Workman® 3200 & 4200 Series Vehicles

Subject: Fuel from Carburetor may Flood Crankcase.

Ref: 04-02 Copyright[®], 1998. The Toro Company

Workman[®] 3200 & 4200 Series Relocating Fuel System Return Line - Carburetor Cleaning

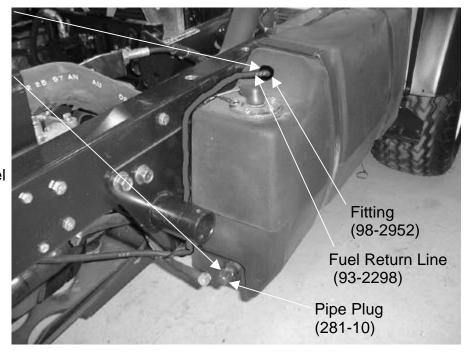
Fuel may enter the carburetor throat through a fuel return line when the engine is off causing fuel to enter the crankcase and the engine to run poorly. This condition is most often the result of debris from the fuel that lodges between the needle and seat, which can prevent the needle and seat from sealing properly.

If your unit experiences this situation, the fuel return line may be relocated as described in the attached instructions. Carburetor cleaning instructions are also included. Further details regarding this bulletin are available through your local Toro distributor.
